Addendum #2

Project Name: Cattle National Bank & Trust - Fallbrook
6550 Merchant Drive
Project No.: 12054
Issued: May 06, 2013
Bid Date: 2:00 pm, CDT May 14, 2013

Revision to Detail **E1/A201**

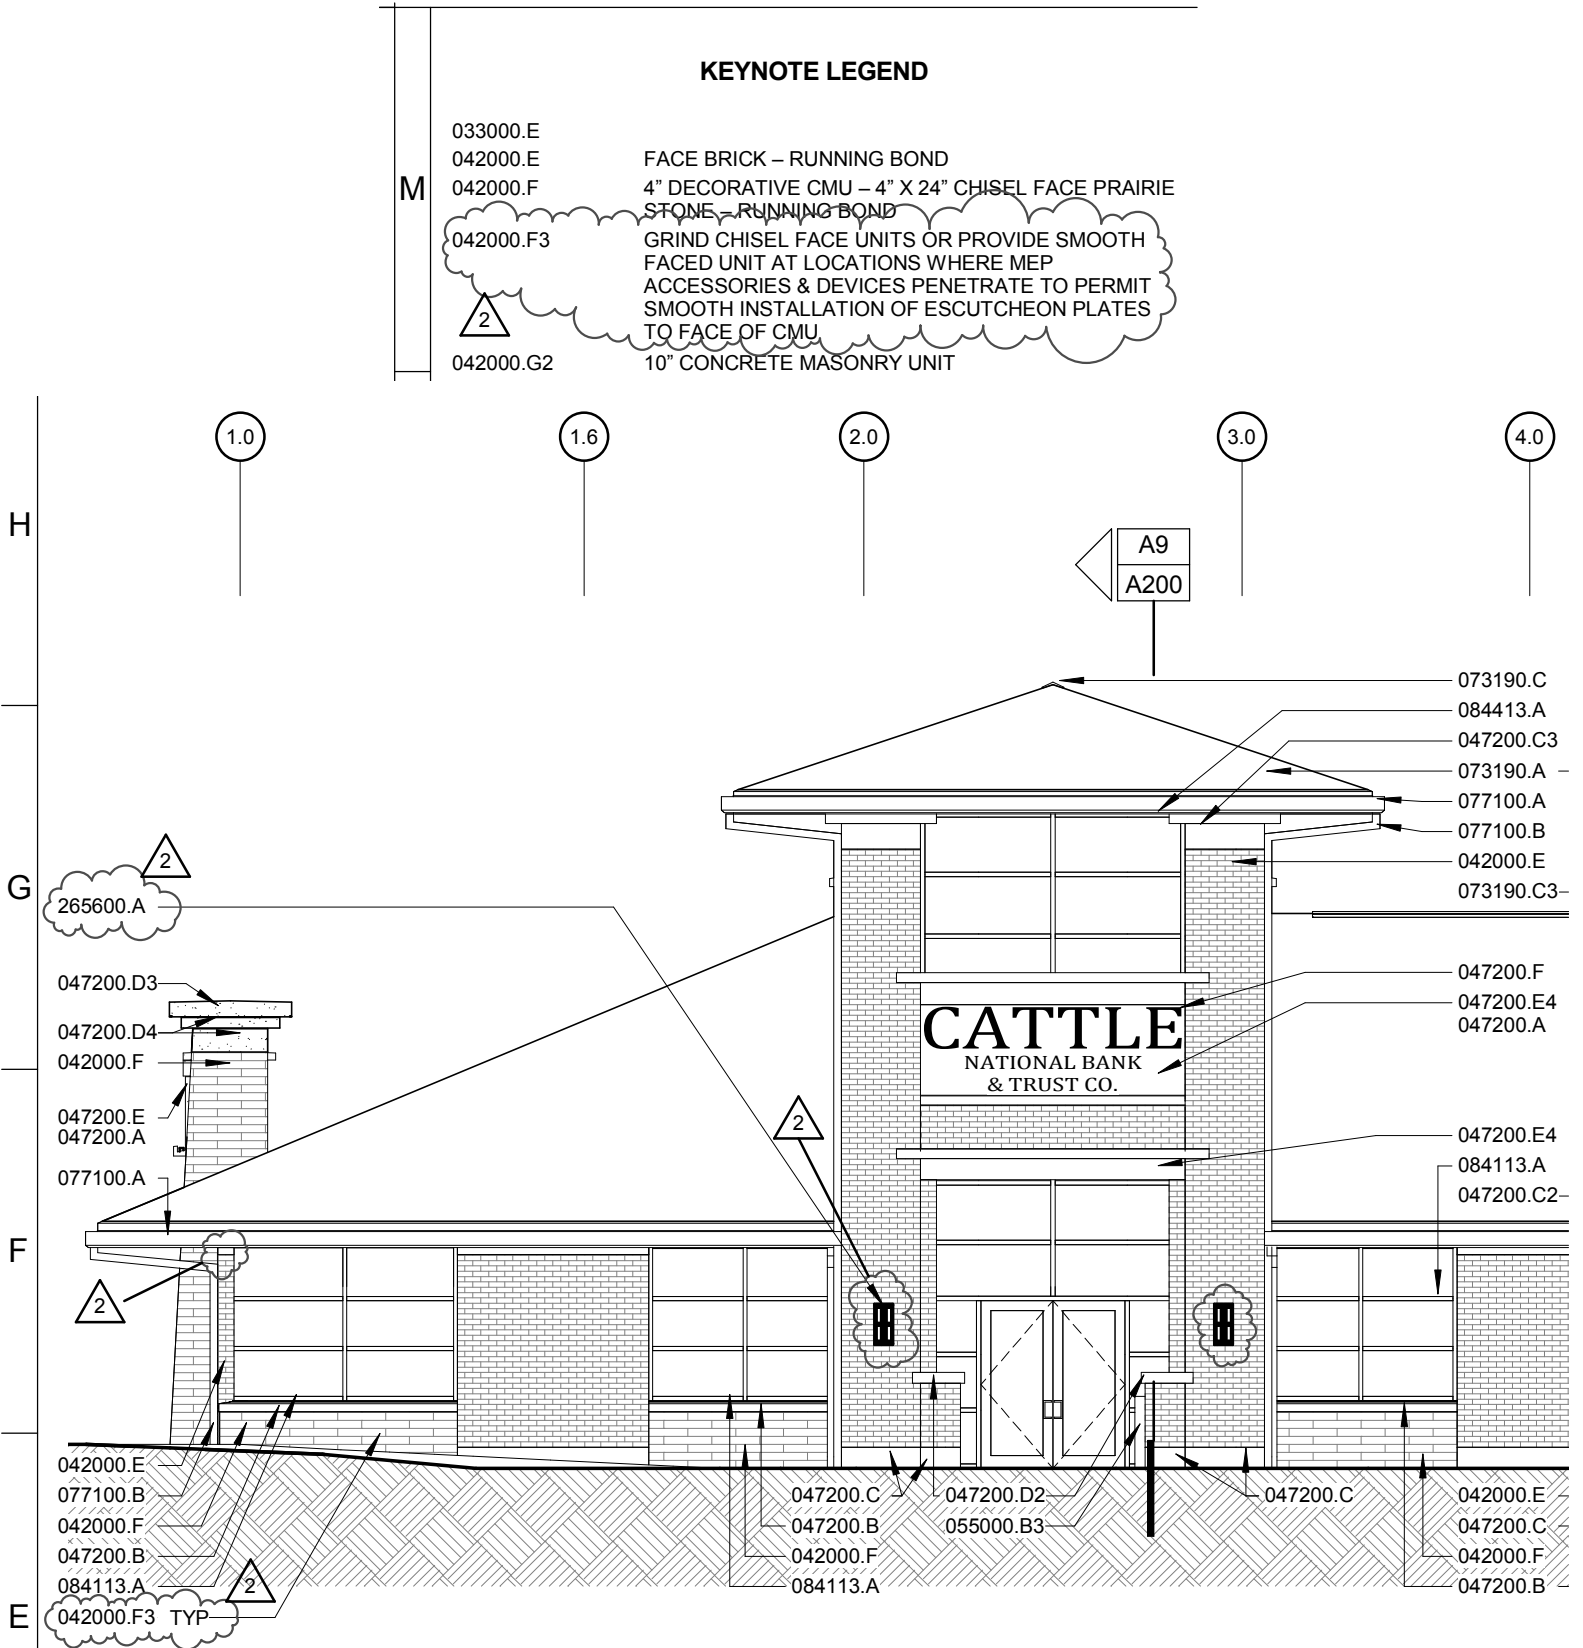
- a. E1/A201: Graphically coordinated elevation to show exterior lights at entrance. Added typical keynote 042000.F3 to elevation. See Attachment A01.

Revision to Detail: A8 & D8/A403

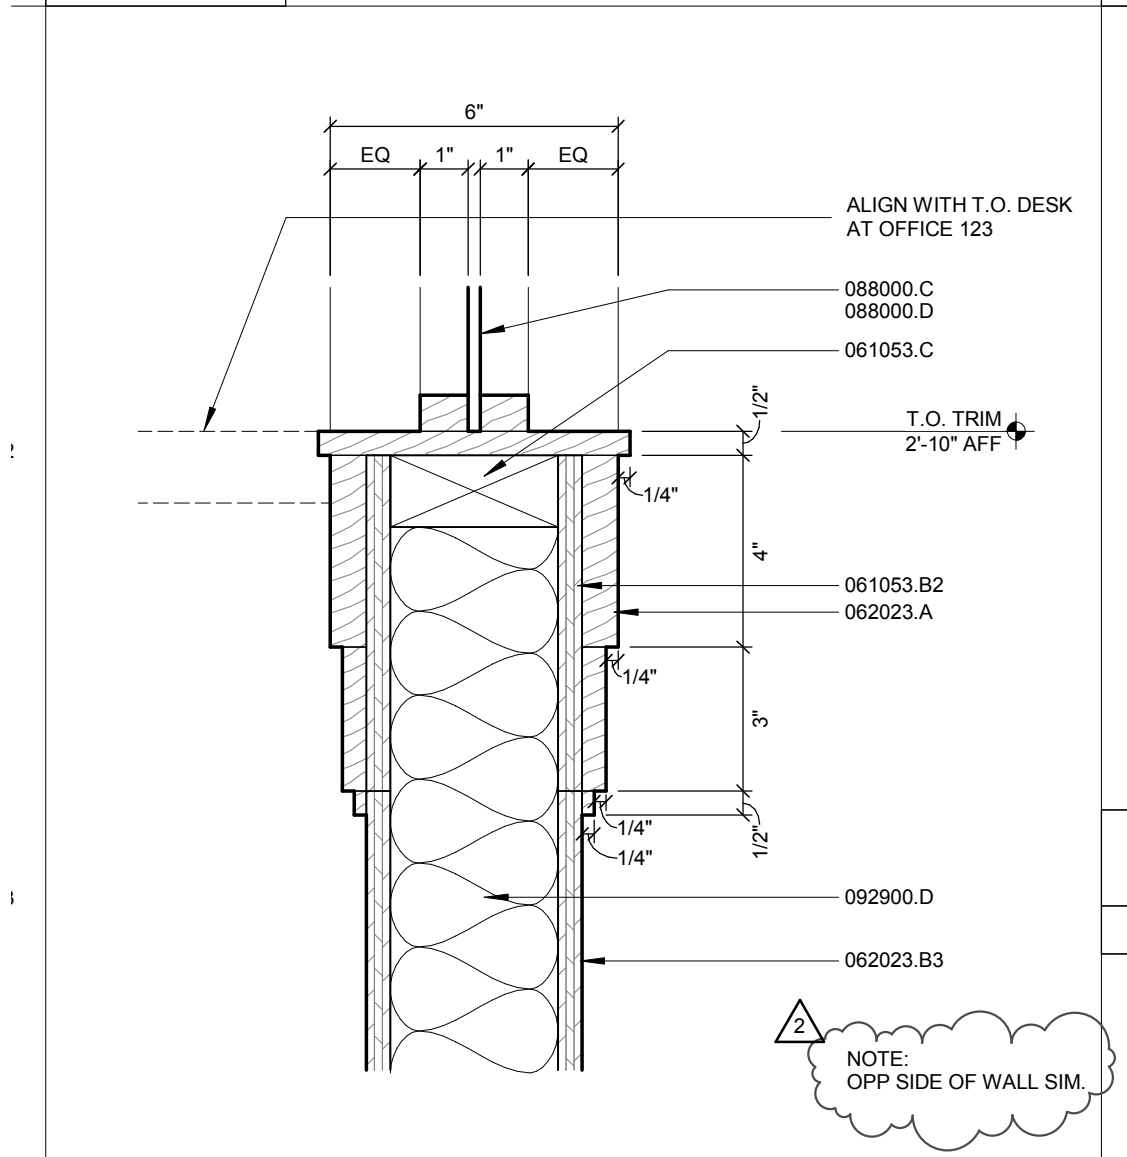
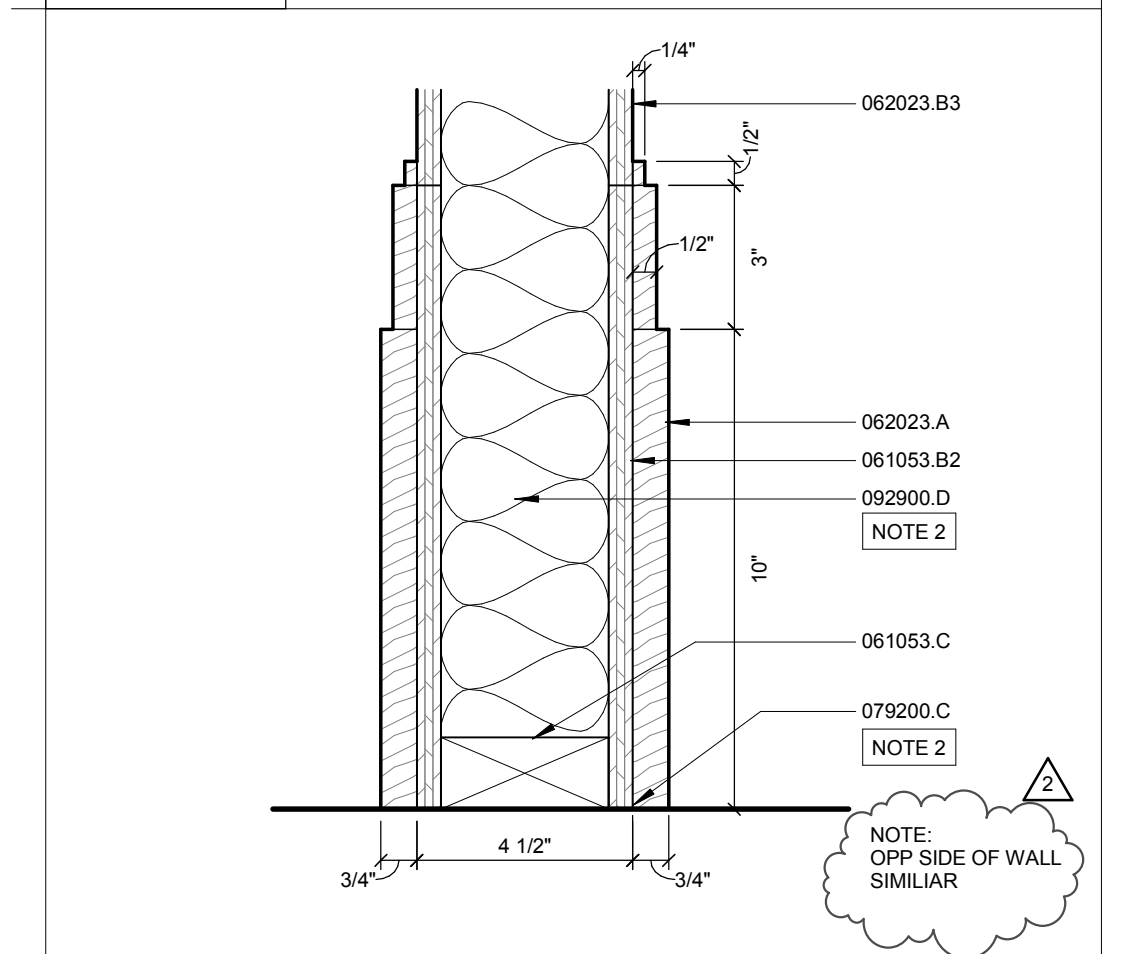
- a. A8/A403: Added note to drawing. Refer to Attachment A02.
- b. D8/A403: Added note to drawing. Refer to Attachment A03.

A501

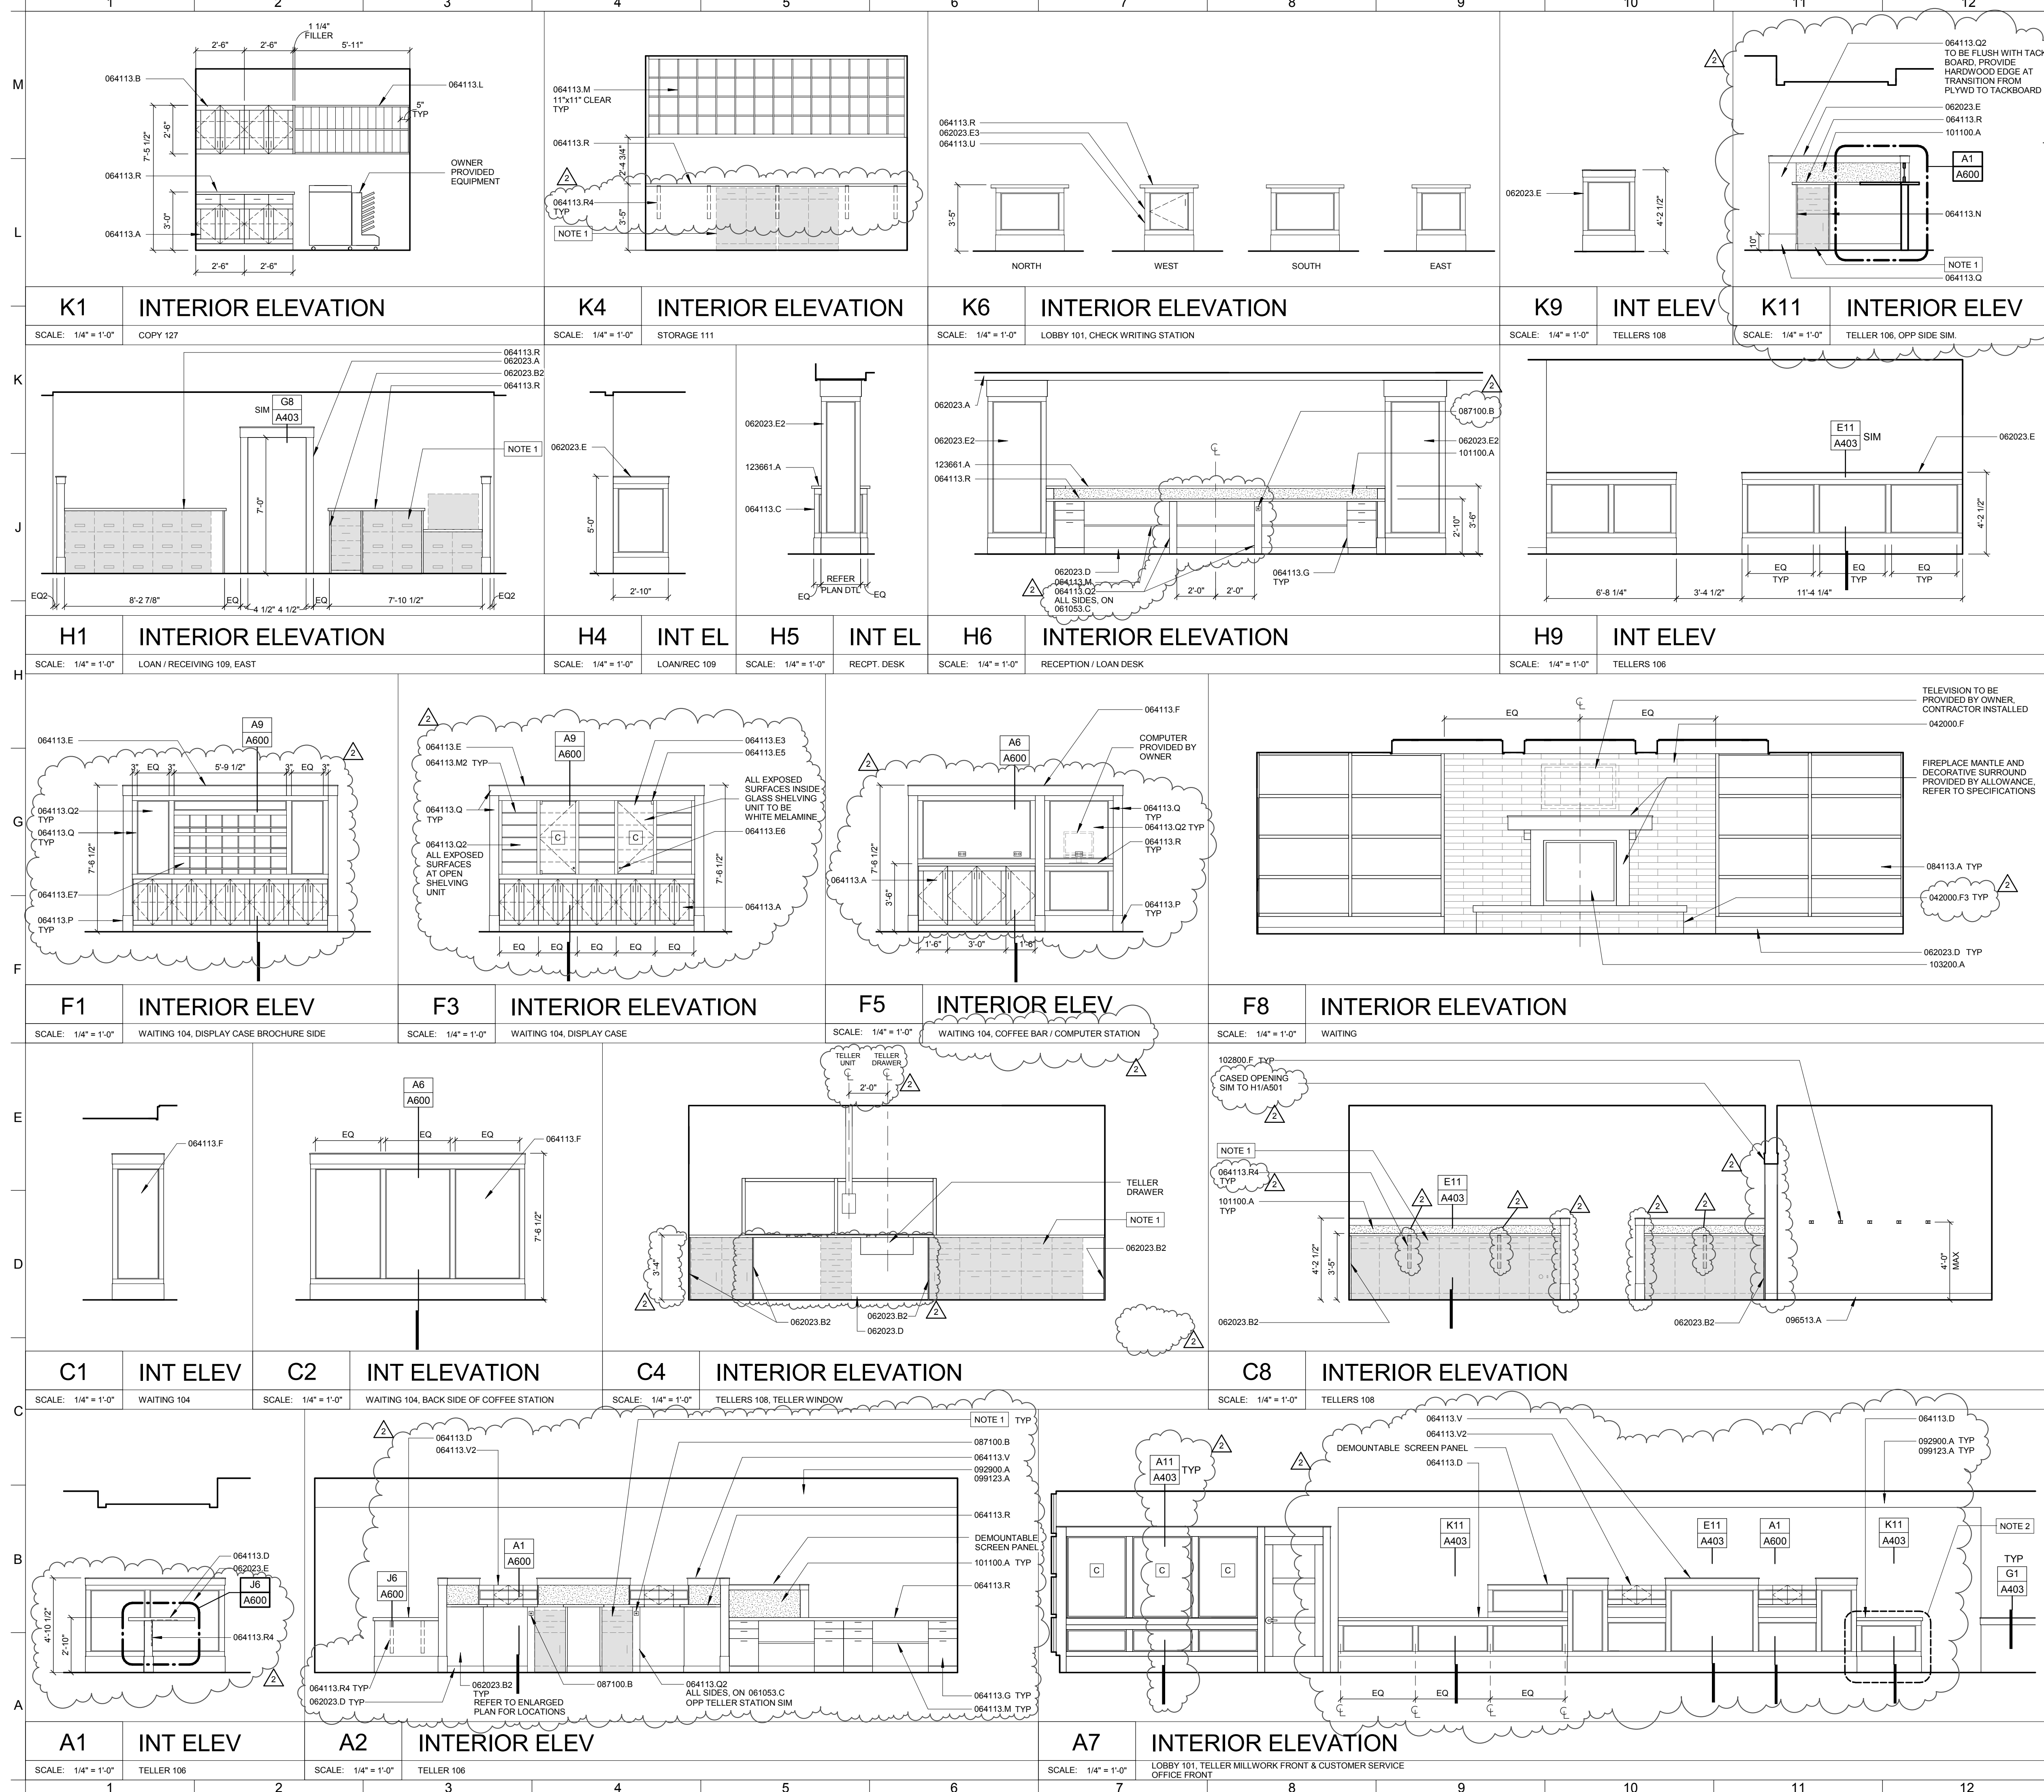
- a. A1/A501: Added dimensions, detail callout tag and keynote. Refer to Revised Sheet A501.
- b. A2/A501: Revised teller station to coordinate with other millwork. Added dimensions and keynotes. Refer to Revised Sheet A501.

- c. A7/A501: Revised teller station to coordinate with other millwork. Added dimensions and keynotes. Added section tag to elevation of office front. Refer to Revised Sheet A501.

- d. C4/A501: Added dimension of 3'-4" from finish floor to underside of counter. Removed Keynote 055000.E "1/4" Steel Panel" and updated the graphic to remove the hatched area of the 1/4" steel panel. Added 2'-0" dimension between the centerline of the teller drawer and the centerline of the teller unit to coordinate with A1/A100. Refer to Revised Sheet A501.

- e. C8/A501: Revised end walls to coordinate with other millwork. Added undercounter brackets, added keynotes and notes. Refer to Revised Sheet A501.
- f. F1/A501: Revised elevation to coordinate with other millwork and detail on sheet A600. Keynotes and dimensions added. Refer to Revised Sheet A501.

- g. F3/A501: Revised elevation to coordinate with other millwork and detail on sheet A600. Keynotes and dimensions added. Refer to Revised Sheet A501.

- h. F5/A501: Revised elevation to coordinate with other millwork and detail on sheet A600. Keynotes and dimensions added. Drawing subtitle added. Refer to Revised Sheet A501.

- i. F8/A501: Added keynote. Refer to Revised Sheet A501.
- j.
- k. H6/A501: Revised undercounter support walls and added keyswitch. Refer to Revised Sheet A501.

- l. K4/A501: Added undercounter brackets. Refer to Revised Sheet A501.
- m. K11/A501: Interior Elevation Added. Refer to Revised Sheet A501. Refer to A110 for elevation callout tag.
